COMMITTEE OF ADJUSTMENT

NOTICE OF PUBLIC HEARING
Minor Variance

APPLICATION NO.:	FL/A-22:250	SUBJECT PROPERTY:	585 SKINNER ROAD, FLAMBOROUGH
ZONE:	UC-14 (Urban Commercial)	ZONING BY-LAW:	Zoning By-law former Town of Flamborough 90-145-Z, as Amended by By-law No. 14-099, 21-129, 21-138

PROPOSED SITE LAYOUT
(File # DA-21-011)

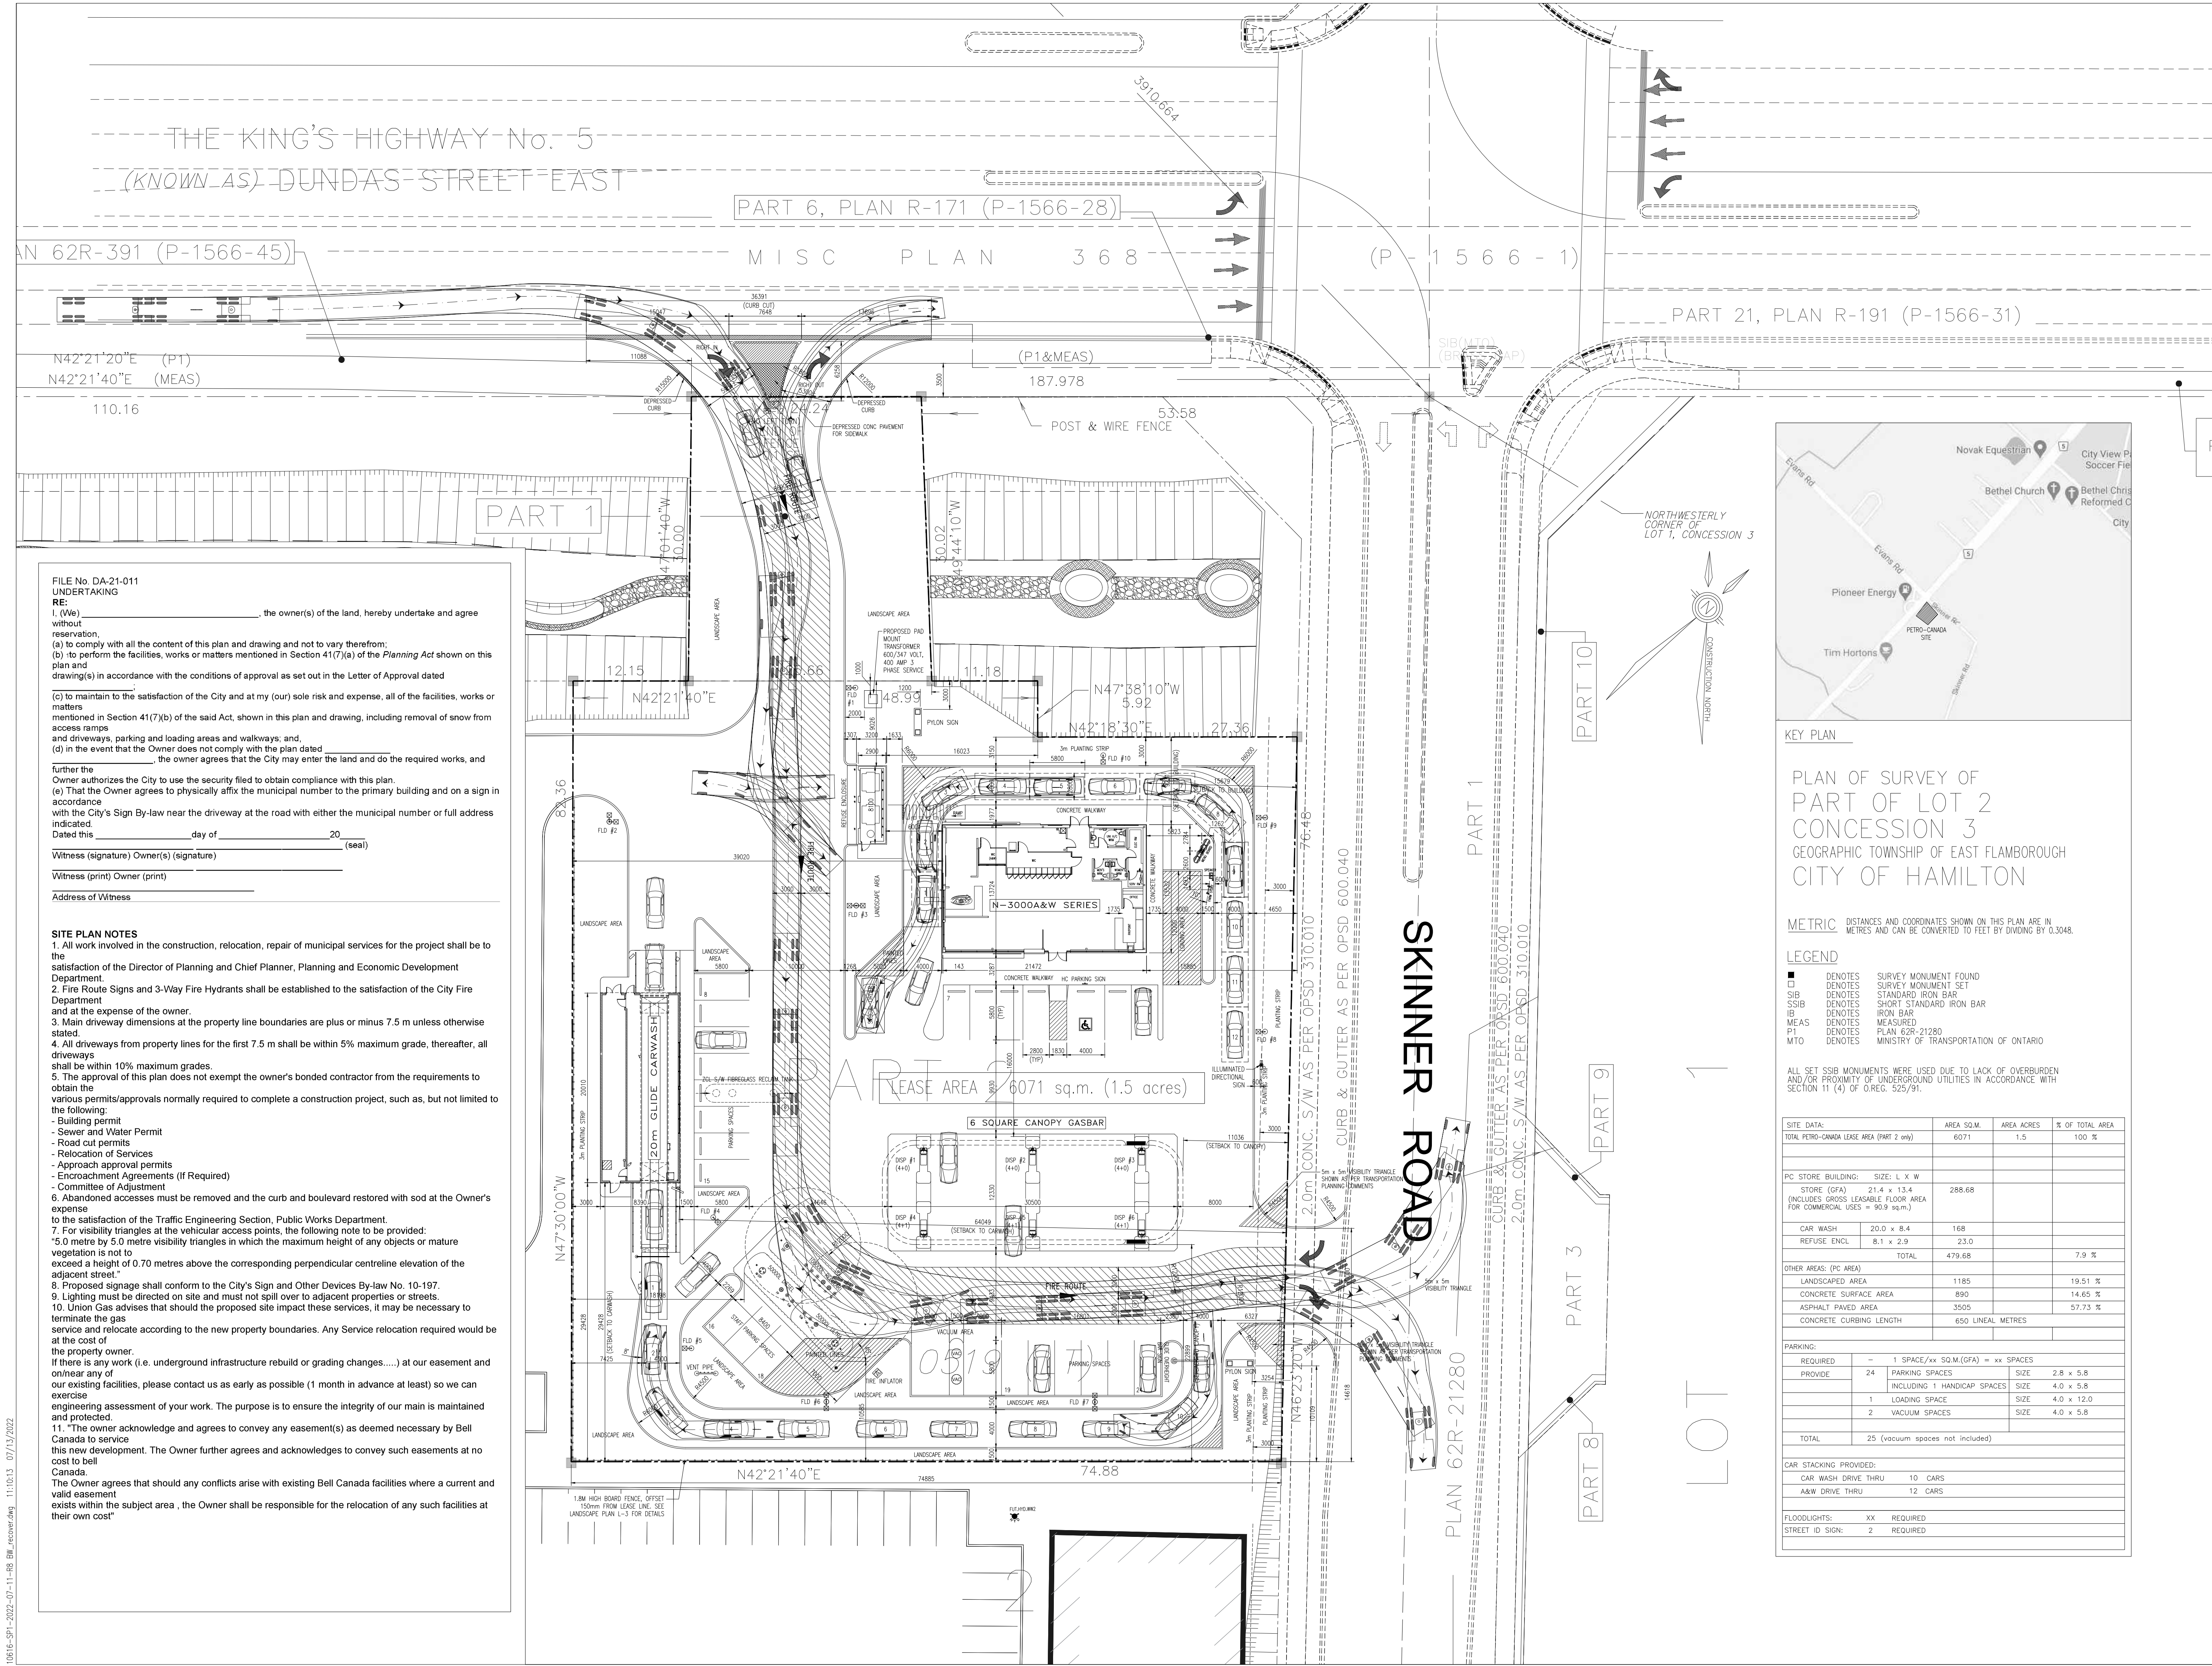
The zoning By-law requires that a loading space shall not be located in the front yard or exterior side yard. The submitted plan shows that the loading space is located within the front yard. The applicant shall ensure that the loading space is relocated to a permitted location; otherwise, further variances shall be required.

The zoning By-law requires a minimum setback of 15.0m from the Conservation Management Zone. The submitted plan shows a setback of 9.23m from the proposed building to the CM zone boundary. The applicant shall ensure that the location of the proposed buildings maintain the required 15.0m setback from the CM zone boundary; otherwise, further variances shall be required.
